# UNITED STATES PATENT AND TRADEMARK OFFICE

10/622,042

## Office Action Summary

### **DETAILED ACTION**

a fore optic/window/substrate 150 having a first side proximate to said plurality of microlenses and having a second side. Figure 19 of Liu is reproduced below.

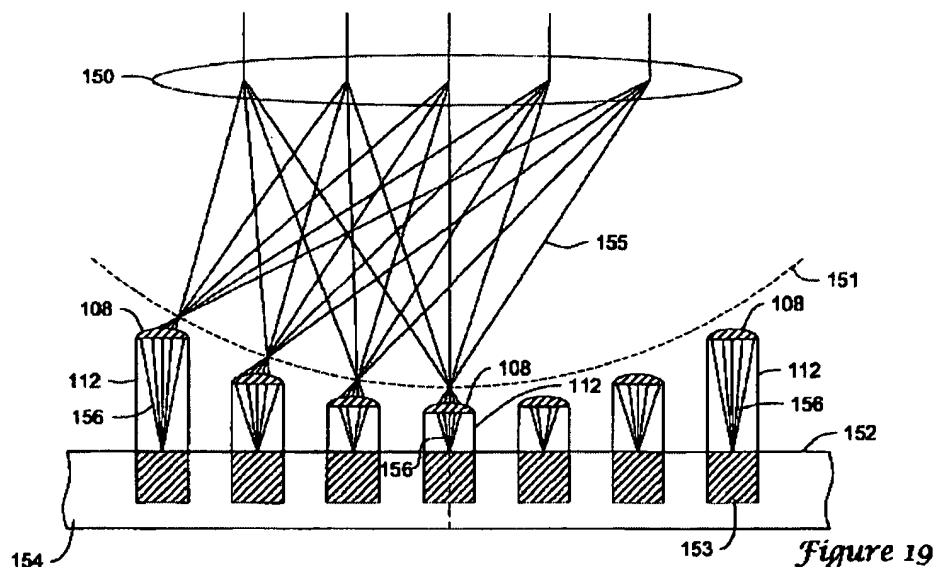
*In re* claims 1, 13, 27, and 37, Liu discloses an optical coupling system (e.g., Figures 19-20) comprising:

a substrate 154 having a plurality of optoelectronic elements 153 formed on said substrate;

a plurality of posts 112 formed over the plurality of optoelectronic elements 153 on said substrate wherein each post has a height of between about 30 microns and about 250 microns (see Fig. 11a; col. 12, lines 24-34; and col. 13, lines 8-10) ;

a plurality of microlenses 108 with each lens 108 formed on a first end of said posts 112, wherein the microlenses have a diameter of between 20 and 60 microns (col. 13, lines 8-10);

*In re* claim 2, the particular limitations are shown in Figure 19 of Liu.

Thus, Liu only differs from claims 1-4, 8-16, 18, 19, 22-24, 27-35, and 37-41, in that Liu does not mention that the fore optic/window/substrate 150 is made of glass. Liu does mention that the fore optic 150 may comprise a lens (column 1, lines 63-65). Glass lenses are well-known in the art. It would have been obviously expedient to use glass in the fore optic 150 of Liu in order to provide an operable lens. Therefore, it would have been obvious to one of ordinary skill in the art at the time of the claimed invention to obtain the invention specified by claims 1-4, 8-16, 18, 19, 22-24, 27-35, and 37-41 in view of Liu.
